1 This document contains suggested text to resolve comments regarding P802-REVC-d1.0.

Figure 1—An example of a bridged IEEE 802 network

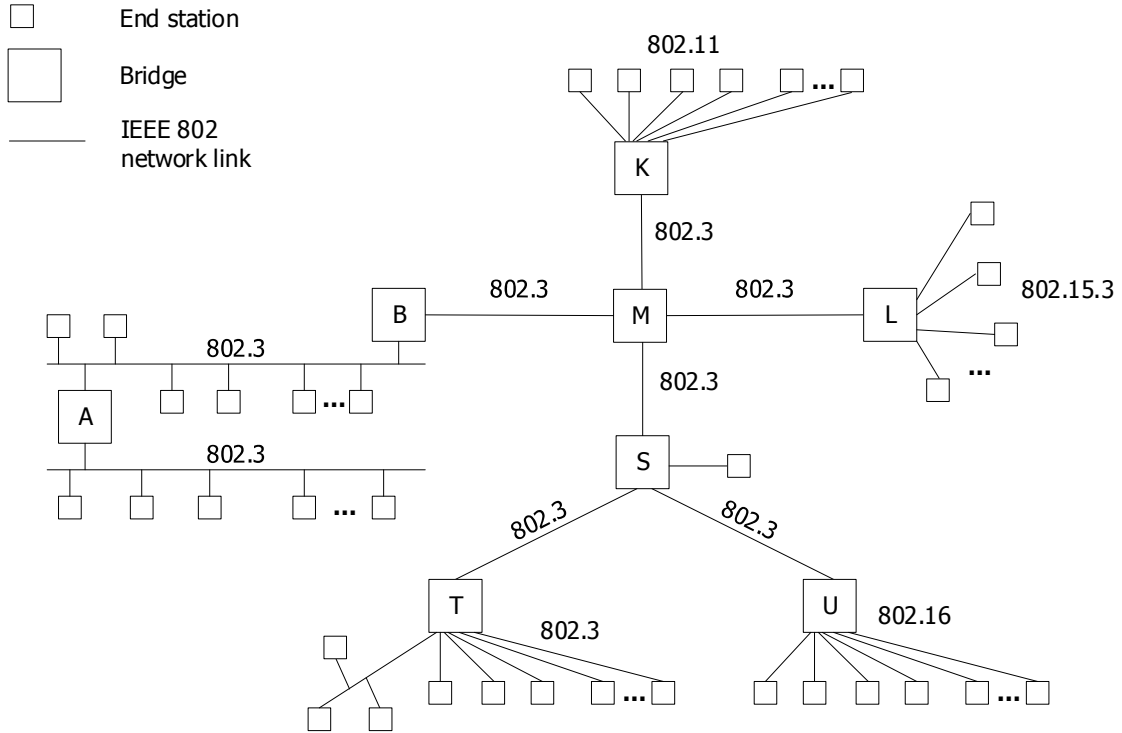
21 *Subclause 5.2.3.6 is now 5.2.3.8 with the changes shown to address CID 4, CID 37, CID 59, and CID 94*

23 Some Bridges are used to interconnect access domains that each contain a very small number of end
24 stations (often, a single end station). Other Bridges interconnect multiple access domains that contain
25 principally other Bridges, ~~thus forming a backbone for the bridged.~~ These Bridges and links are referred to
26 as an IEEE 802 backbone networks. Bridged IEEE 802 network configurations that involve these kinds of
27 interconnection have become widespread as the technologies have developed. These configurations allow
28 the construction of networks with much larger numbers of end stations and much higher aggregate
29 throughput than was previously achievable.

30 Figure 1 illustrates an example of a bridged IEEE 802 network that can be configured with bridge-style
31 interconnection. The Bridges A and B, and the IEEE 802.3 LAN configurations to which they attach, are
32 typical of the older style of bridged IEEE 802 network in which a Bridge interconnects a small number of
33 access domains, each containing many end stations, as is similar with K ~~and~~ L and ~~M~~ their IEEE 802.17™
34 ring. The ~~IEEE 802.17 ring and the~~ IEEE 802.3 connections to M and those between S and T and S and U
35 form IEEE 802 backbone networks. On the other hand, the Bridges S, T, and U function as Bridges that
36 ~~combine IEEE 802.17, IEEE 802.3, and IEEE 802.16™ networks.~~ S and M are is backbone B bridges on an
37 IEEE 802 backbone network, handling a number of network attachments. T and U are Bridges that support
38 multiple end stations, with connection to an IEEE 802 backbone network. B and K also provide access to an
